Annotated Marked Up Drawings

Application Serial No. 10/826,197

Title: CLOCK DOUBLER

FIG. 1

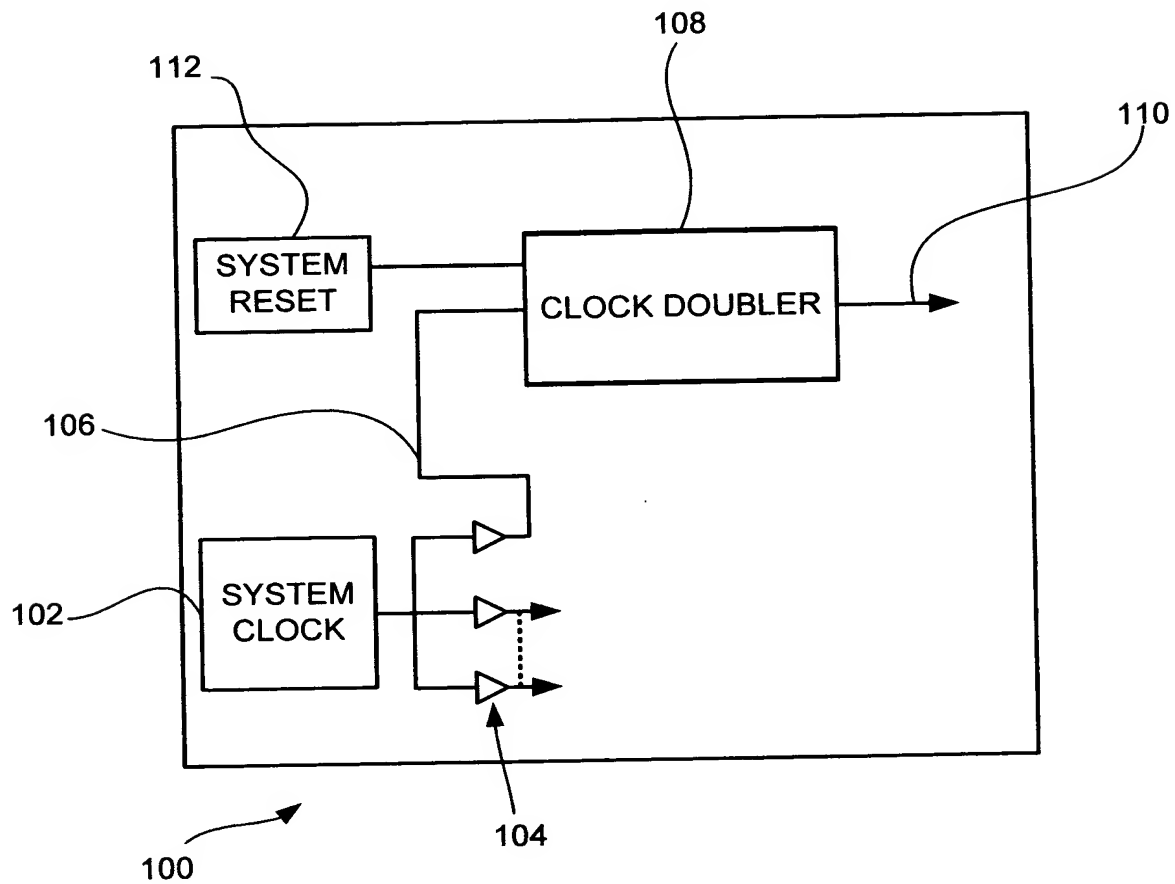
**The Examiner has objected to the drawings because all black boxes in FIG. 1 need text labels; the timing circuitry 260 is not labeled in FIG. 2; and the Examiner cannot determine which elements of the drawings form the timing circuitry 255 and 260 due to unclear labeling.**

"all black boxes in Fig. 1 need text labels"

Nonetheless, Applicant has amended FIG. 1 to provide text labels in the interest of moving prosecution forward. Accordingly, Applicant respectfully submits that this objection has been overcome. Withdrawal of this objection is warranted, and such action is hereby solicited.

FIG. 2

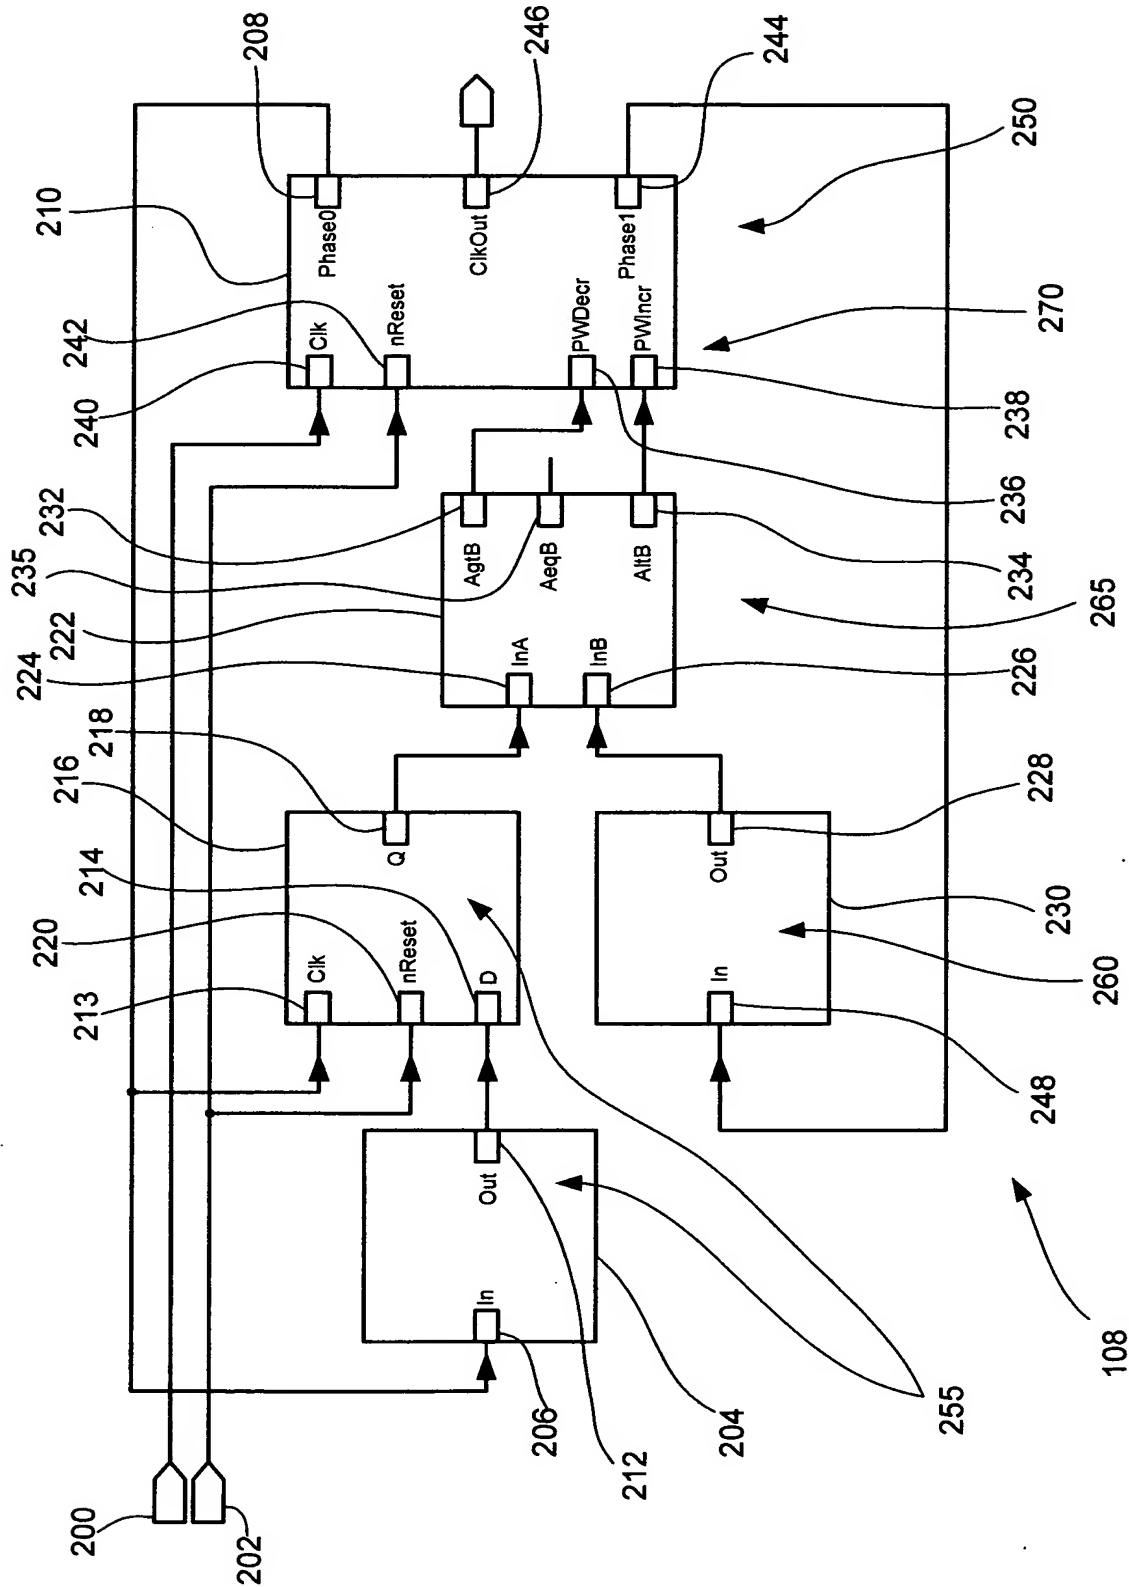
“With respect to claim 1 line 10, the recited "tap delay line for delaying the system clock" is unclear because the tap delay line (Figure 2, 204) does not receive the system clock (Figure 2, 200).

“the Examiner cannot determine which elements of the drawings form the timing circuitry 255 and 260”

FIG. 2 has been amended to clarify which elements of FIG. 2 form the timing circuitry 255 and 260. Accordingly, Applicant respectfully submits that this objection has been overcome. Withdrawal of this objection is warranted, and such action is hereby solicited.
